Subject: Revision 3 to Byron Station Unit 1 Cycle 11A Core Operating Limits Report

**Byron Station Unit 1 Cycle 11A Core Operating Limits Report  
Revision 3**

Subject Byron Unit 1 Cycle 11A Core Operating Limits Report in ITS Format and W(z) Function

b) When PDMS is Inoperable,  $W(Z)$  is provided in Figures 2.6.2.a through 2.6.2.d

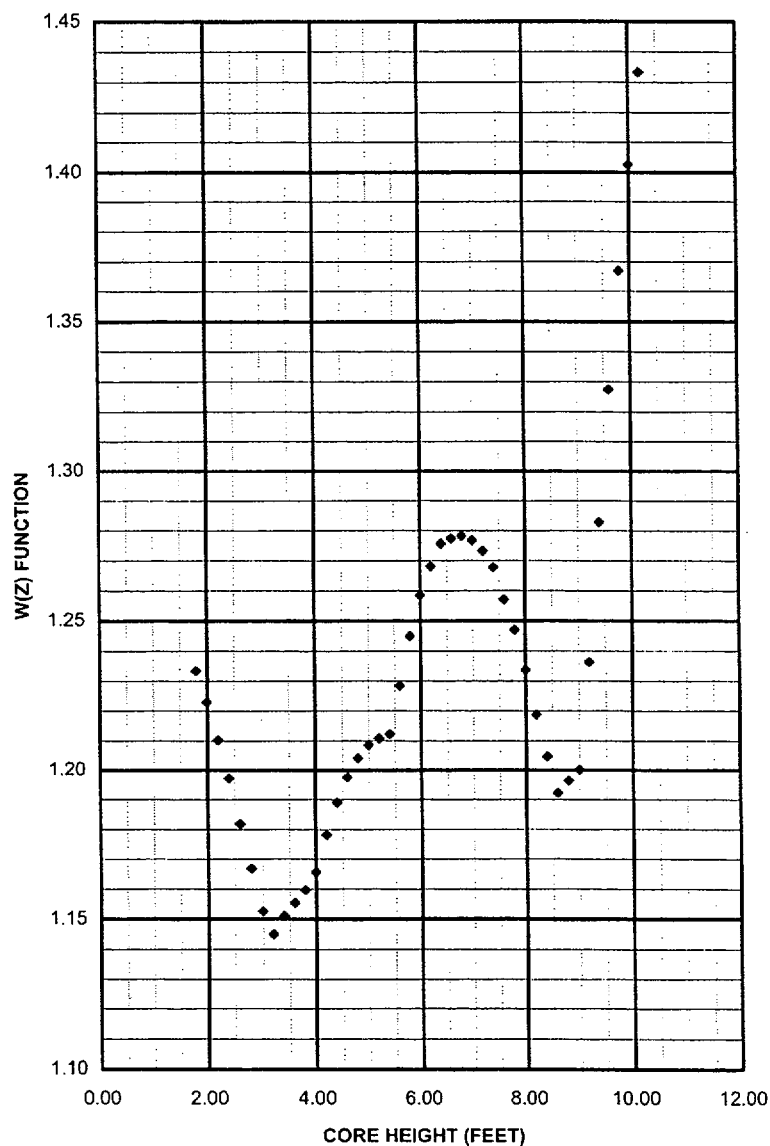
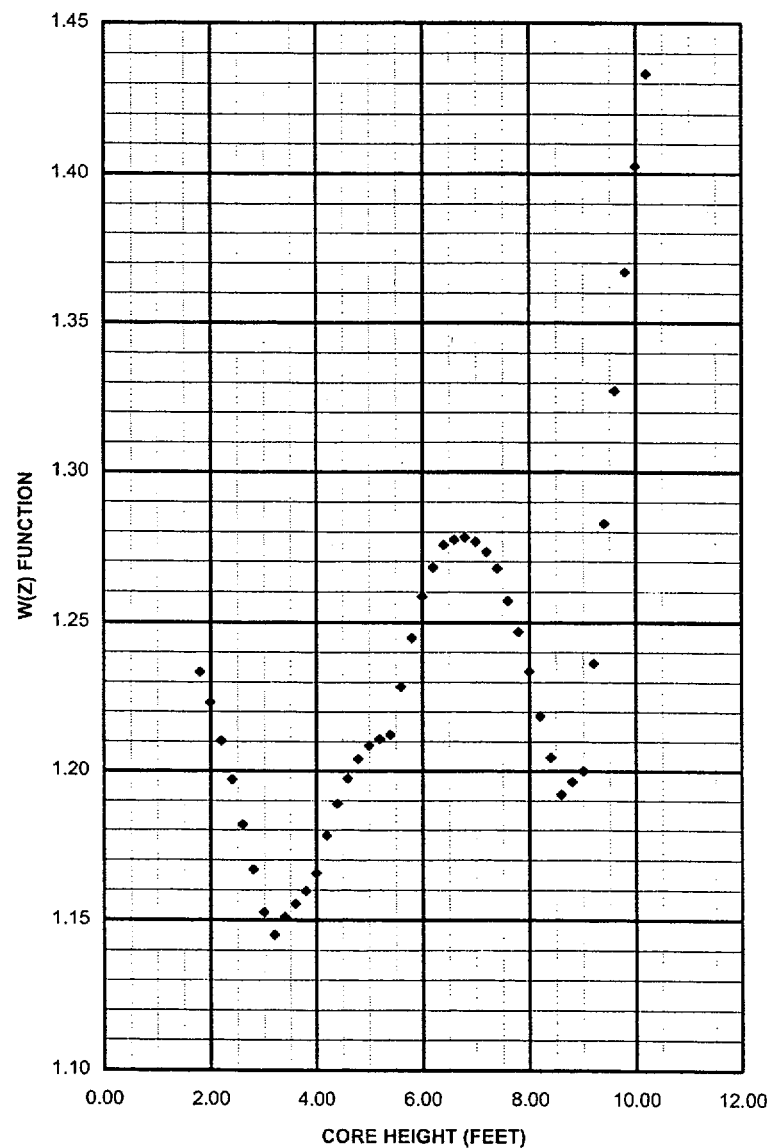
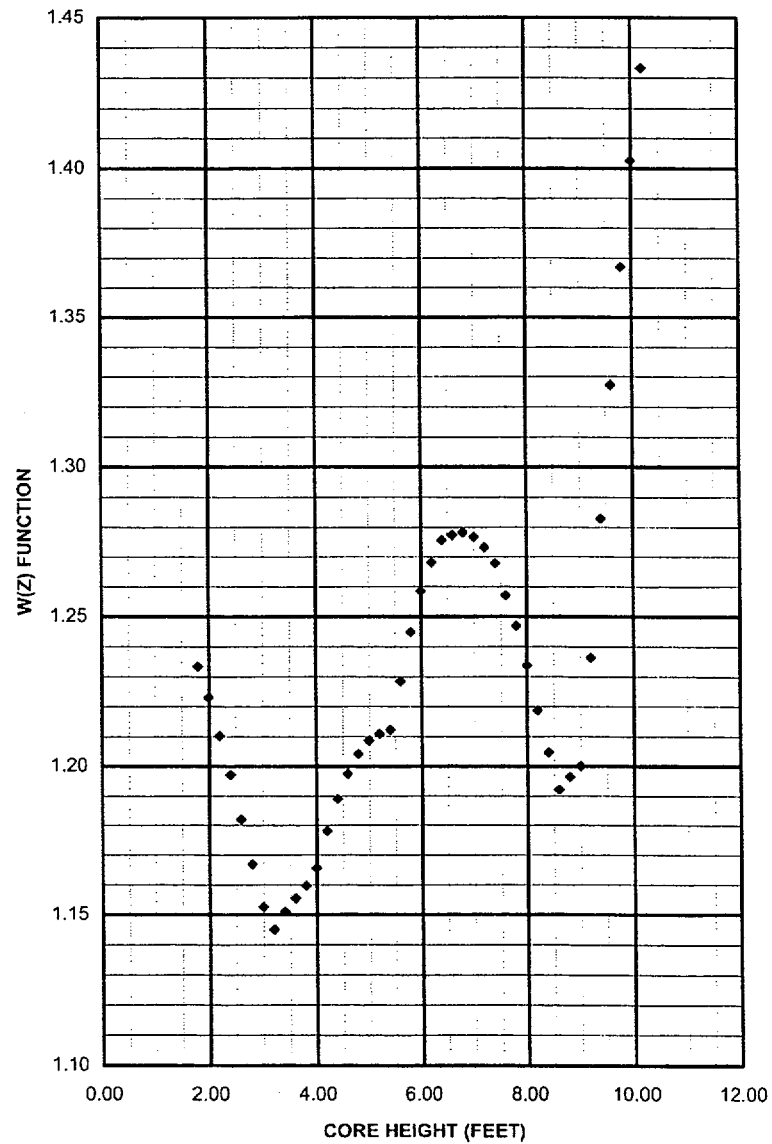
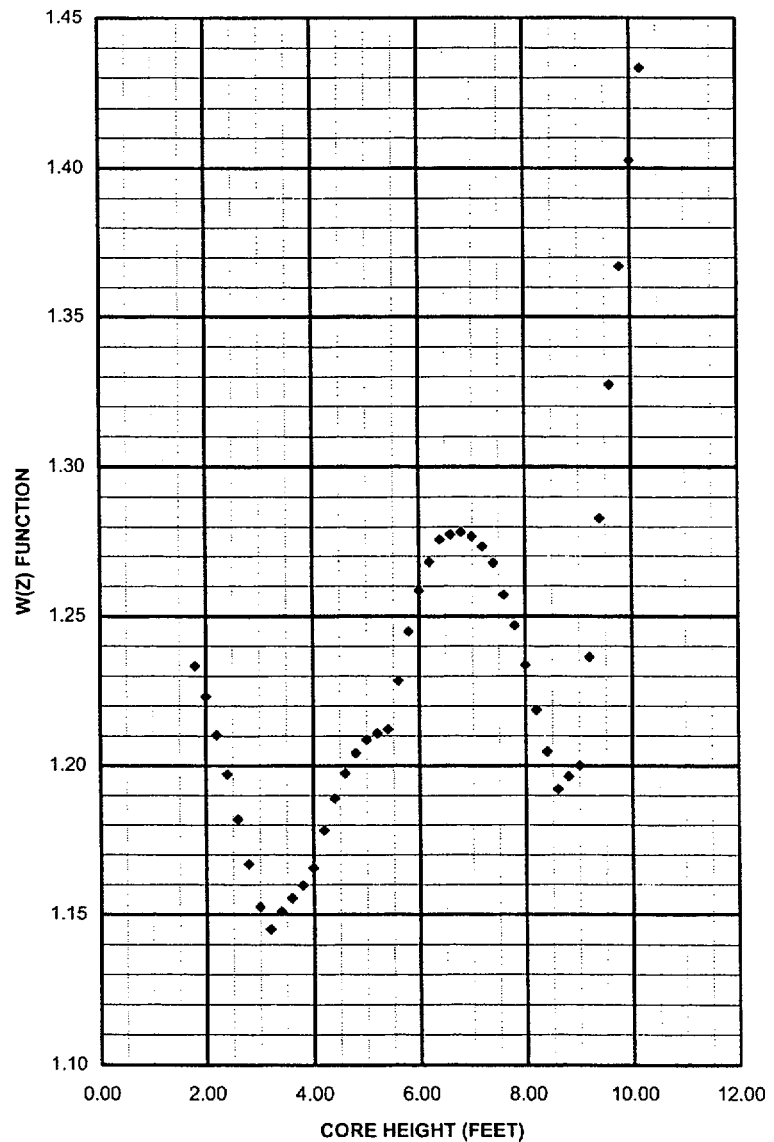
In accordance with Technical Specification 5.6.5, "Core Operating Limits Report (COLR)," we are submitting Revision 3 to the Unit 1 COLR. The Unit 1 COLR was revised to specify the power distribution transient function (i.e.,  $W(z)$ ) for cycle burnup of 18000 MWD/MTU and beyond. Please note that Revision 2 of the COLR was issued but not implemented due to Plant Review comments. These comments were addressed and incorporated into Revision 3.

In Revision 3, the wording for Item 2.6.2 will be revised to say "W(z) values have been specified for burnups of". This is only a wording change to more clearly describe the change. In Revision 2, the W(z) factors were revised to eliminate the overly conservative extrapolation of the W(z) factors past 18000 MWD/MTU. The same set of W(z) factors are provided at 17000, 18000, 22000, and 25000 MWD/MTU (Reference 6). In Revision 1, the SDM limits for MODE 5 were revised to 1.3%  $\Delta k/k$  for LCO 3.1.1. Revision 1 also incorporates the EOL HFP ARO MTC surveillance limit at 60 ppm. Byron Station is requested to perform a Plant Review of this document. Upon completion of the Plant Review, Byron Station is to transmit the COLR portion to the Nuclear Regulatory Commission pursuant to Technical Specification 5.6.5. Please provide NFM (Brian Manges) with a copy of Byron Station's completed Plant Review and COLR submittal to the NRC.

The normal operation  $W(Z)$  values have been specified for burnups of 17000, 18000, 22000, and 25000 MWD/MTU.
